ENGINE - LP COMPRESSOR - ADDITIONAL PLATE NUT ON THE NO.1 STRUT FAIRING PANEL FOR FIRE SHIELD - CATEGORY CODE 8 - MOD.ENG-72-0216

V2500-ENG-72-0216

SERVICE BULLETIN

Before and after modification of the No.1 strut fairing panel
Fig.1 (Sheet 1 of 2)

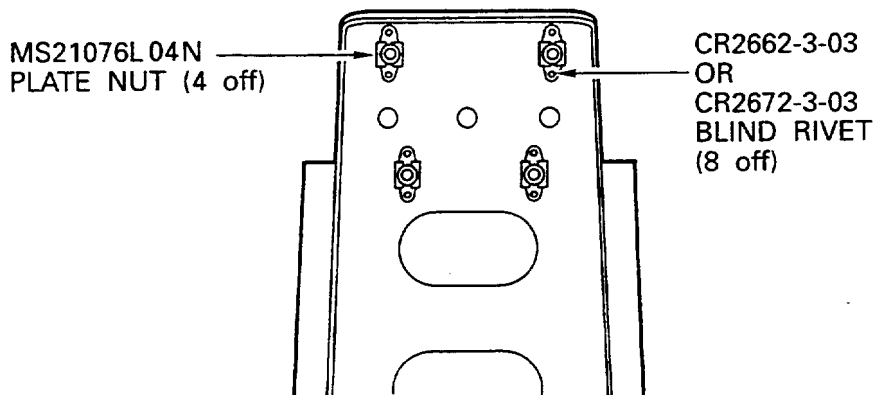
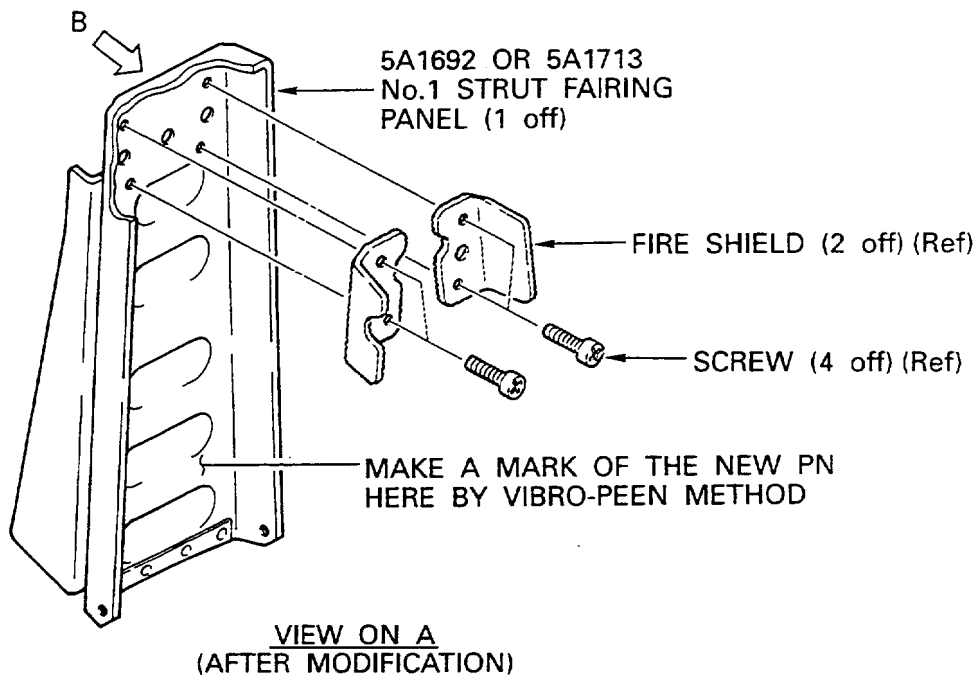
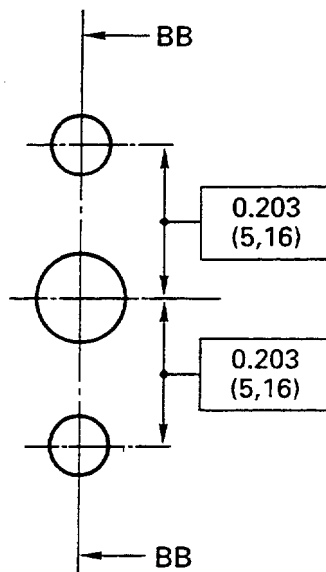
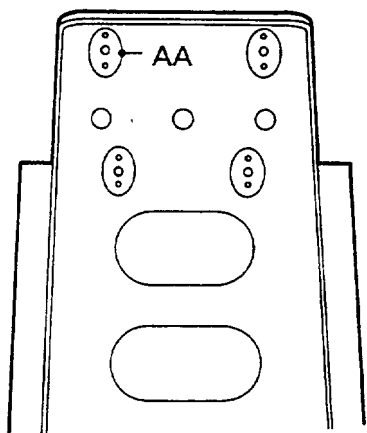
The existing fire shield is secured by bolts and nuts with washers on the No.1 fairing panel, but this installation is difficult to remove the fire shield at the on-wing condition, because of hard access to the nuts and washers.

Replace the current nuts and washers with plate nuts to enable the fire shield to be replaceable at the on-wing condition.

- (a) Four plate nuts are introduced at the four screw positions on the No.1 strut fairing panel to revise the current nuts and washers (see Figure 1).
- (b) The rivets which secure the plate nut are introduced at the eight positions on the No.1 strut fairing panel (See Figure 3).

(j) Make a mark of the new part No. on the No.1 strut fairing panel adjacent to the old part No., make two lines (==) on the old part No. to erase it

Use the Vibro-Peen method, Refer to Figure 1 (Sheet 2 of 2)

Old Part No.	New Part No.
5A0212	5A1692
5A1411	5A1713

Drilling position of the No.1 strut fairing panel
Fig.2

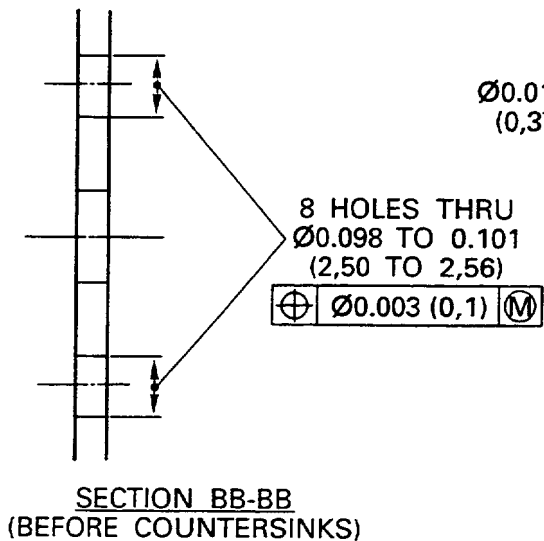
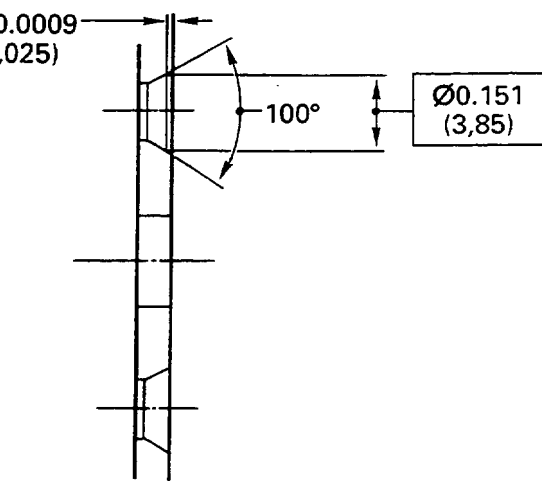
- (2) The existing No.1 strut fairing panel can be reworked to a new configuration (See Figure 2 and Figure 3).

Procedure	Supplementary Information
(a) Set-up and make sure the drilling positions (eight positions)	Refer to Figure 2, requirements
(b) Drill the applicable holes for one position (two holes in each) and do a same modification on other three positions (six holes) on the No.1 strut fairing panel	Refer to Figure 2, Use a 0.098 to 0.101 in. (2,50 to 2,56 mm.) drill

(c) Examine	Make sure holes are correctly drilled
(d) Countersinks the eight drilled holes where shown	Refer to Figure 2, Use standard workshop equipment

*DO A SAME MODIFICATION ON OTHER CIRCLE
MARKED AREAS (3 POSITIONS)

Install the plate nut onto the No.1 strut fairing panel
Fig.3

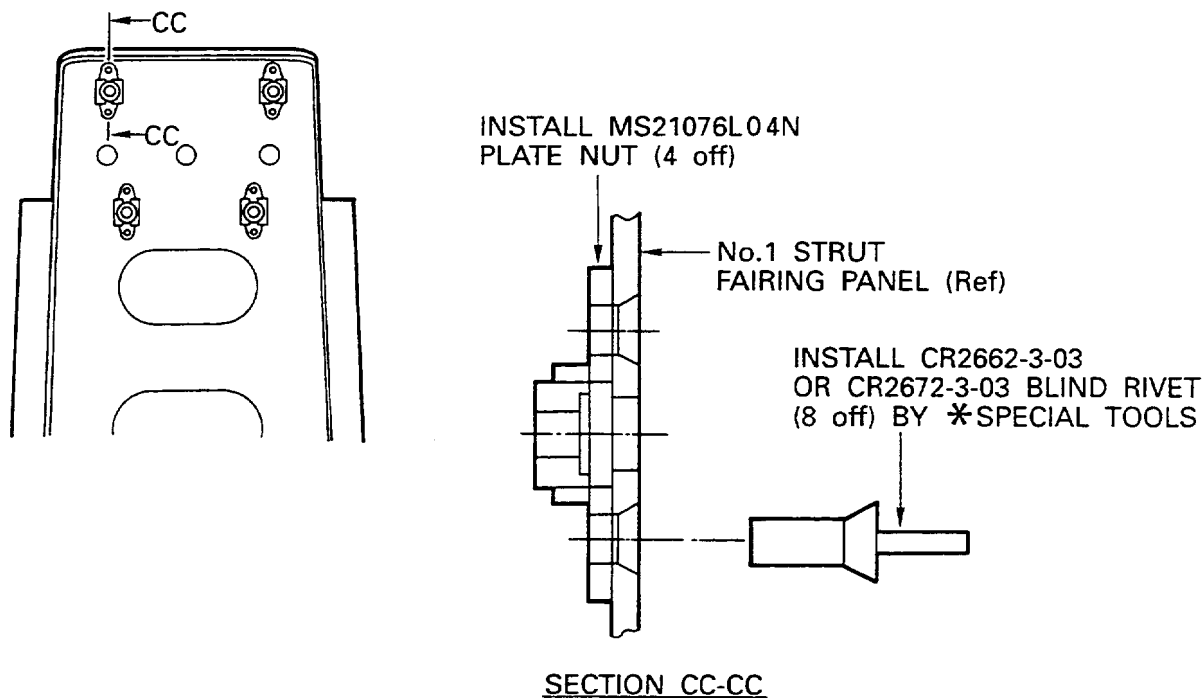
(g) Do a crack test the affected areas	Refer to SPM TASK 70-23-05-230-501 penetrant inspection
(h) Attach the plate nut onto the applicable four positions of the No.1 strut fairing panel	Use MS21076L04N, plate nut Refer to Figure 3

(i) Install rivets into the plate nut through the holes at eight positions	Use CR2662-3-03 or CR2672-3-03 blind rivet and the formed rivet must have no cracks and must be tight Refer to Figure 3

*THE SPECIAL TOOLS SHOULD BE USED TO INSTALL RIVET IN ORDER TO AS FOLLOWING LIST;

Type	Rivet	Special Tool
A	CR2662-3-03 (*1)	IAE3J12743 and IAE3J12744
B	CR2672-3-03 (*2)	IAE3J12743, IAE3J12793 and IAE3J12794

NOTE: (a) If you want to use (*1) rivet,
you have to use Type A tools.
(b) If you want to use (*2) rivet,
you have to use Type B tools.
